Pulaski County Schools
Energy Savings and Performance Contract
Addendum #2
March 25th, 2022

CMTA Contact:	Megan Brangers
Email:	MBrangers@cmta.com
Cell Phone:	502-919-1521

The following information supersedes or is in addition to information released in the Contract Documents dated March 11th, 2022 and addendum 1 dated March 18th, 2022.

M4-4.0

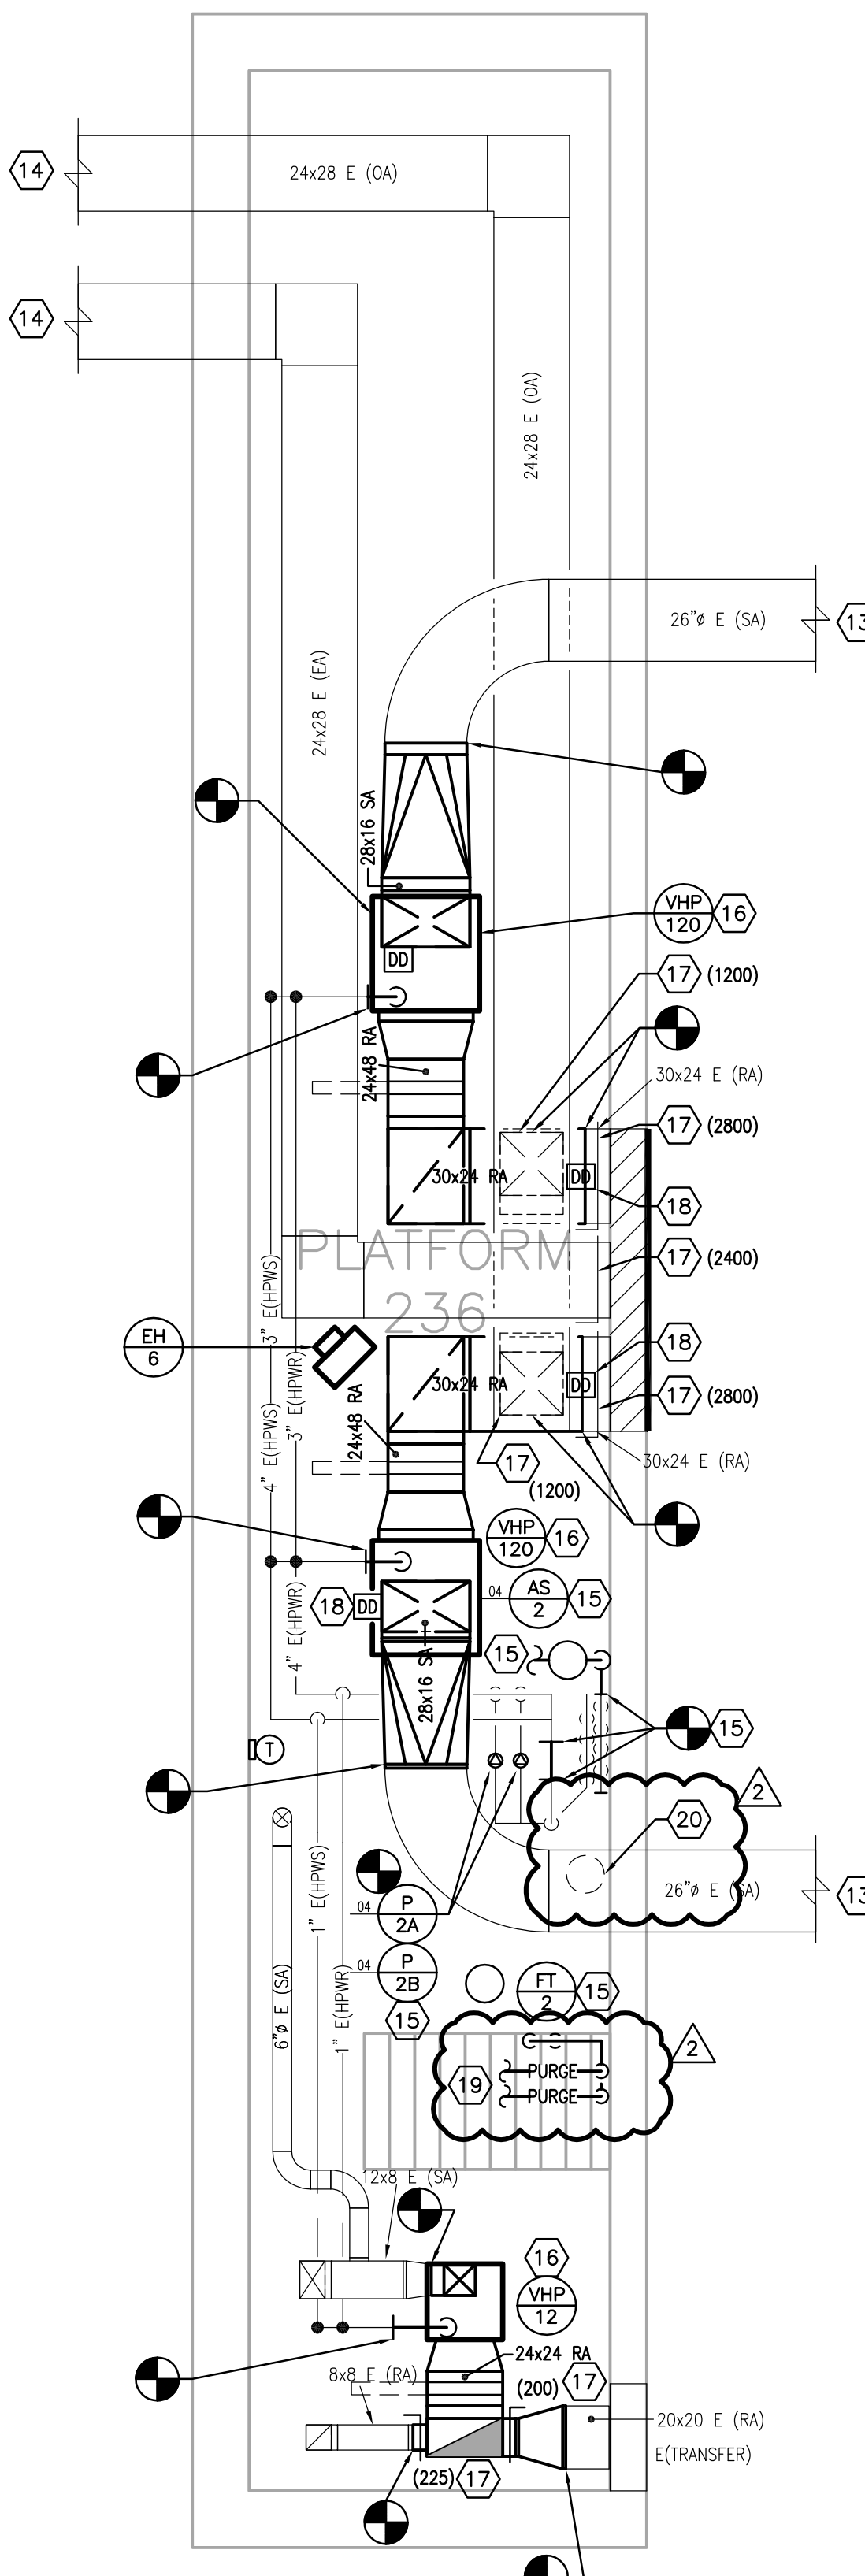
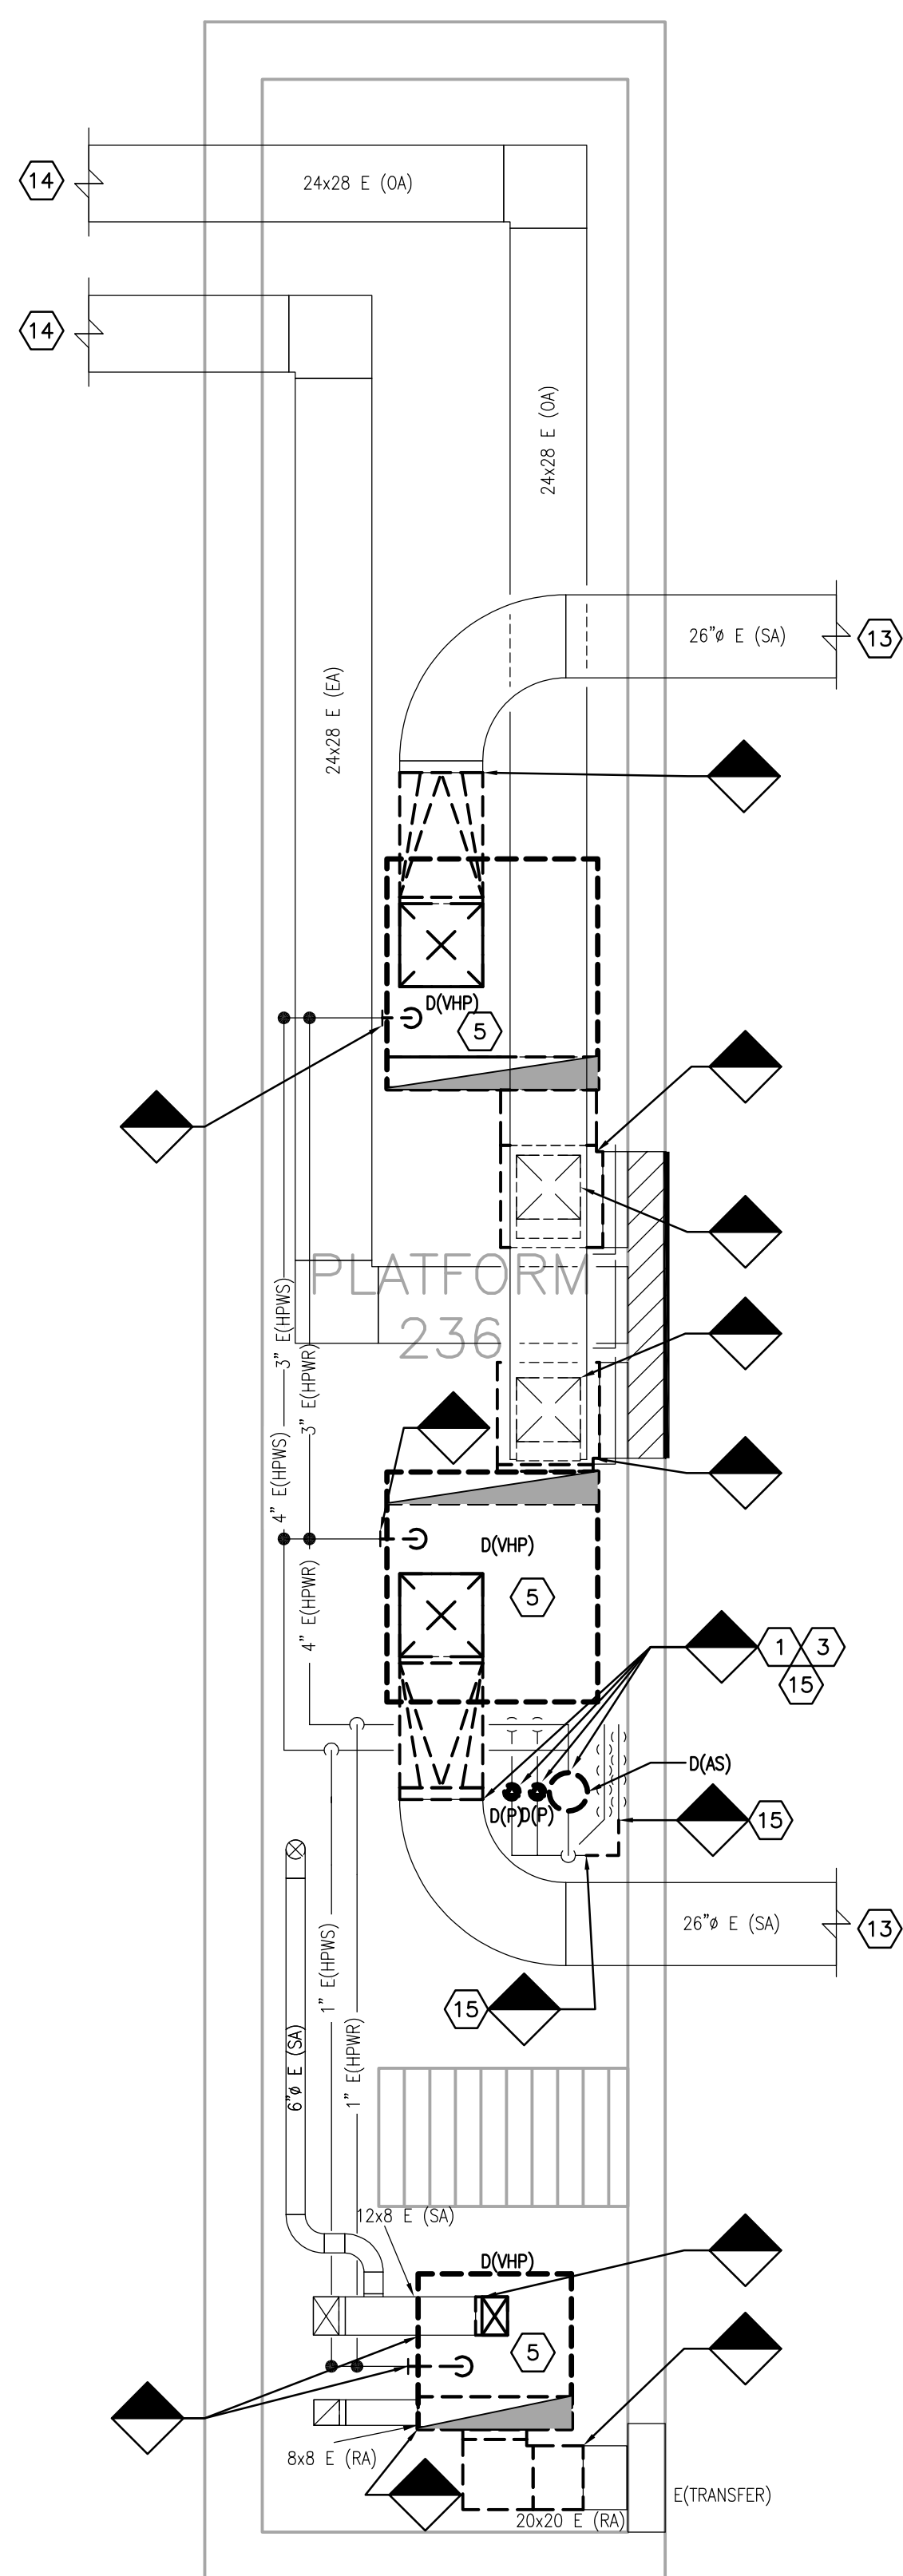
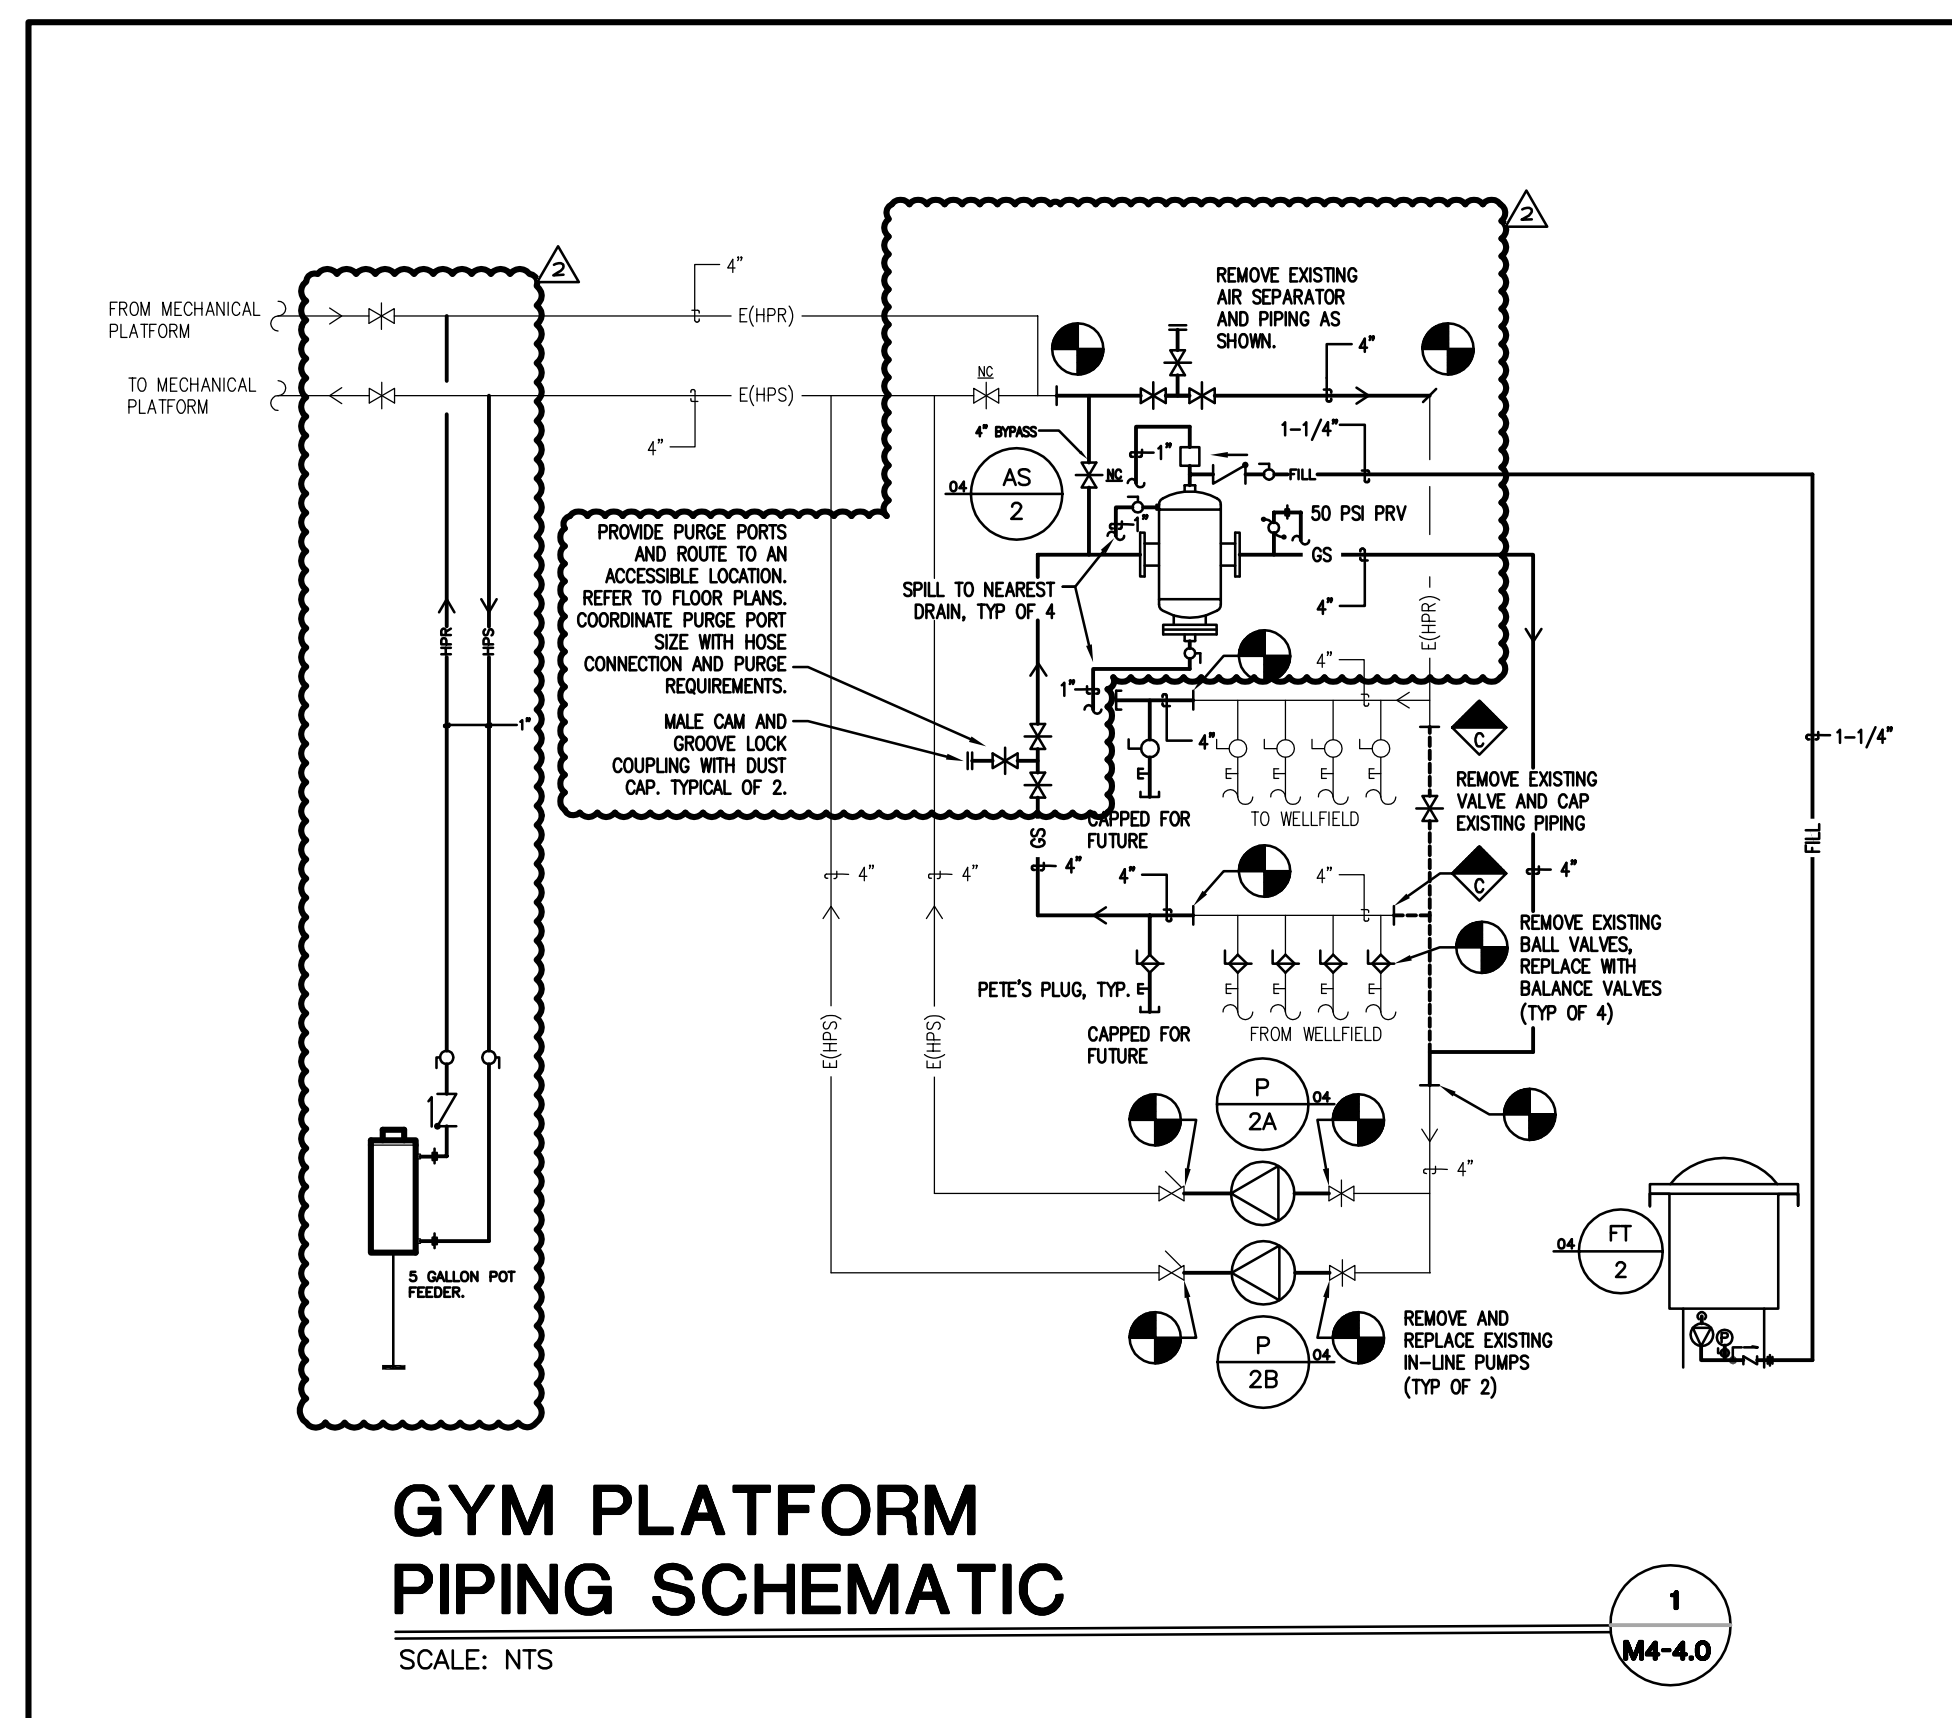
23. Drawing M4-4.0

- a. Refer to Enlarged Platform 236 – Mechanical for revised geothermal and heat pump piping. Add purge ports and tag note 19. Add 5-gallon pot feeder.
- b. Refer to 'Gym Platform Piping Schematic' for updates. Add geothermal wellfield bypass and purge ports. Add 5-gallon pot feeder.
- c. Refer to Enlarged Boiler Room 140B – Mechanical for revised geothermal and heat pump piping. Add geothermal wellfield bypass and purge ports
- d. Refer to 'Geothermal Piping Schematic' for updates. Add geothermal wellfield bypass and purge ports.
- e. Change EH-6 to EH-7.
